DEPARTMENT OF THE AIR FORCE  
HEADQUARTERS 377TH AIR BASE WING (AFMC)

**Subject: Soil Vapor Extraction Well Design, Location, and Installation  
Interim Measures Work Plan, Bulk Fuels Facility Spill, Solid Waste Management  
Units ST-106 and SS-111  
Addendum November 2011  
Albuquerque, New Mexico**

BULK FUELS FACILITY  
 KIRTLAND AIR FORCE BASE, NEW MEXICO

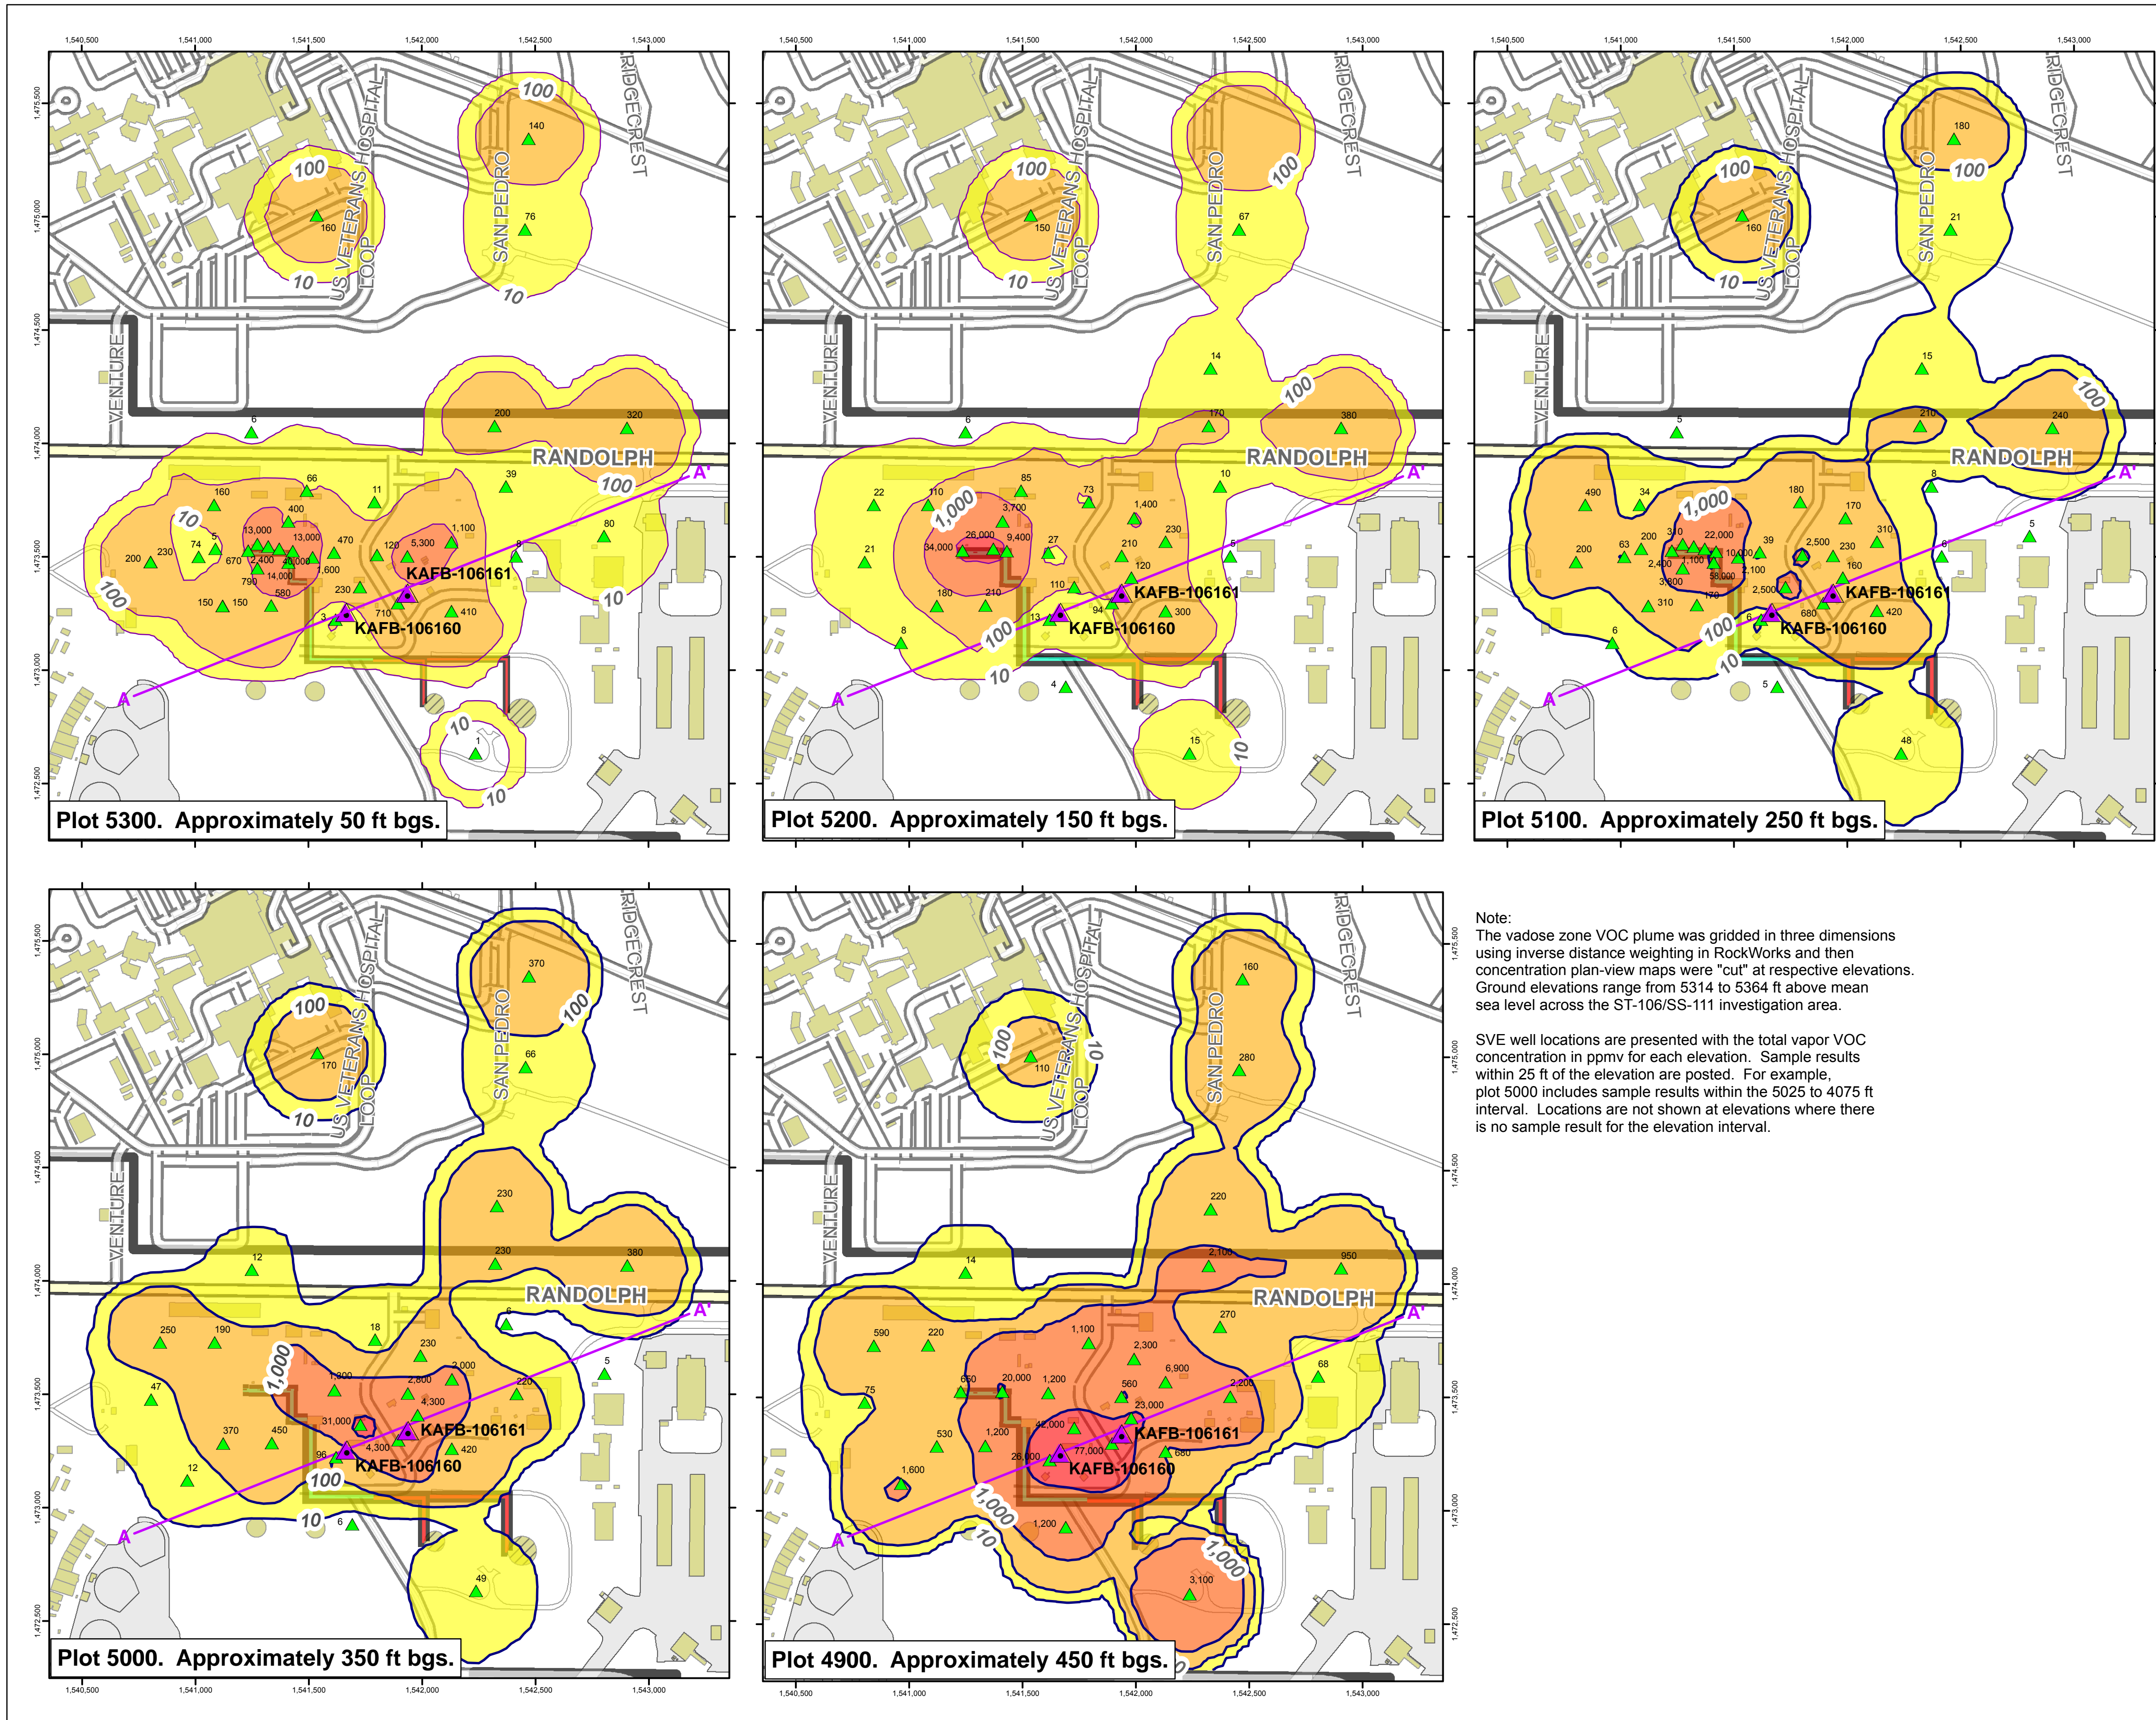
Two SVE wells with screen intervals across the water table will be installed. Each SVE well will consist of a single borehole drilling to an approximate depth of 530 feet bgs with each borehole containing a single well casing. The well casing will be 6-inches in diameter, welded, Schedule 40 steel casing. Each well will contain a 50-foot section of 0.050-inch slot, stainless steel wire-wrapped screen followed by a 10-foot section of Schedule 40 stainless steel casing connected to a 40-foot section of 0.050-inch slot, stainless steel wire-wrapped screen. Below the water table, there will be a section of 0.030-inch slot, stainless steel wire-wrapped screen. The well will be completed with a 5-foot sump at the bottom of the well. Figure 2 is a schematic diagram of SVE well construction.

**FIGURE 1**  
 LAB TOTAL VAPOR VOC PLUME  
 FOOTPRINTS BY ELEVATION  
 JUNE 2011

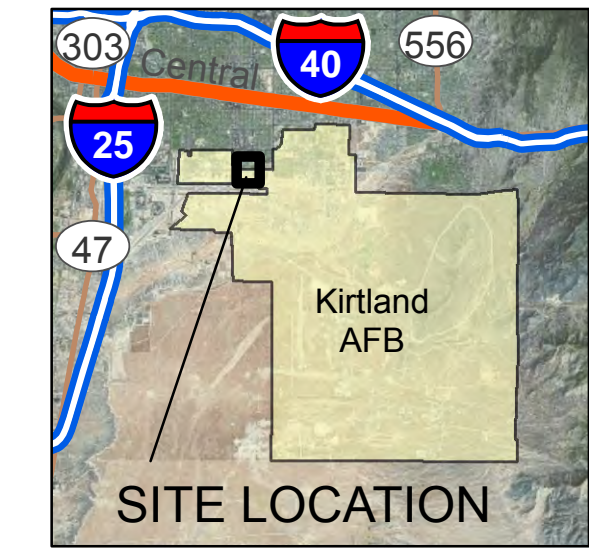
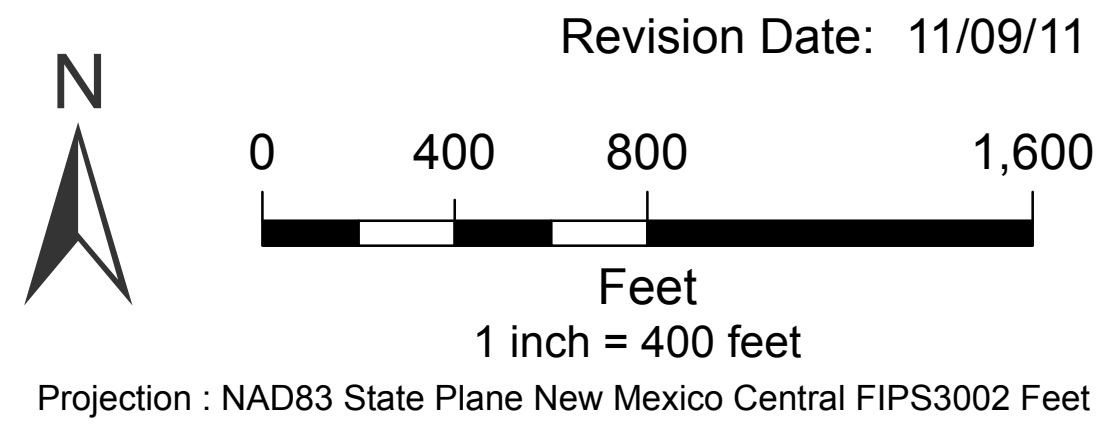
Figure 1, attached to this letter, shows the proposed locations of the two SVE wells, KAFB-106160 and KAFB-106161. Both wells are located on the installation and are within the region showing the highest concentration of vapor based on the results of Quarter 2 (April – June) 2011 data (Figure 1). The spacing of the wells is based on the vapor results, as well as a preliminary understanding of the radius of influence for soil vapor extraction units screened in the vadose zone.
